Access Compliance Report

Public Rights-of-Way

(Curb Ramps)

Intersection ID: 52448	Main Street: WOODWARD_AV	Cross Street: DOUBLE_OAKS_RD	Location: NE
ADA ID: AB69A5CF686F	Ramp Type: Directional1	Initial Pass/Fail: Fail	Overall Compliance: No
Severity Score: 13.75			
Codes/Mitigation Info/Possible Solution		Field Measurements/Component Compliance

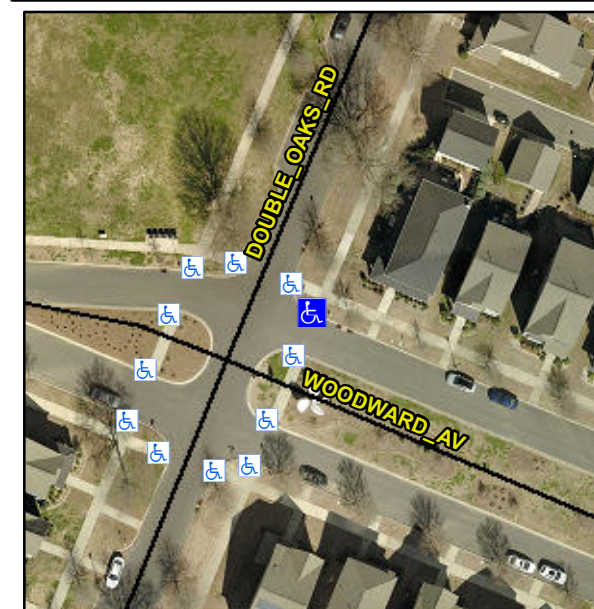
R304.2.2, R304.5.3

Compliance	Description	Data	Compliance	Description	Data
N/A	Ramp Length (in)	96.0	N/A	Grade Break?	N/A
Yes	Ramp Width (in)	68.0	N/A	Grade Break Slope (%)	0.0
No	Ramp Slope (%)	10.5	N/A	Grade Break XSlope (%)	0.0
No	Ramp XSlope (%)	2.2			
N/A	Flare Type LT	N/A	N/A	Flare Type RT	N/A
N/A	Flare Slope LT (%)	N/A	N/A	Flare Slope RT (%)	0.0
N/A	Flare Traversable LT?	N/A	N/A	Flare Traversable RT?	N/A
N/A	Landing Length (in)	0.0	N/A	DWS Provided?	N/A
N/A	Landing Width (in)	0.0	N/A	DWS Contrast?	N/A
N/A	Landing Slope (%)	0.0	N/A	DWS Length (in)	N/A
N/A	Landing X Slope (%)	0.0	N/A	DWS Full Width?	N/A
N/A	Landing Curb? (Y/N)	N/A	N/A	DWS Offset LT (in)	N/A
N/A	Shared Landing?	N/A	N/A	DWS Offset RT (in)	N/A
N/A	Gutter Ponding?	0.0	N/A	Gutter Slope (%)	N/A
N/A	Gutter Lip Ht (in)	0.0	N/A	Gutter X Slope (%)	N/A
N/A	Painted X Walk1?	No		Road Slope (%)	1.7
	X Walk 1 Direction	To S		Road X Slope (%)	1.9
	X Walk 1 Width (in)	N/A		Clear Space?	N/A

Remove & Replace Entire Ramp.
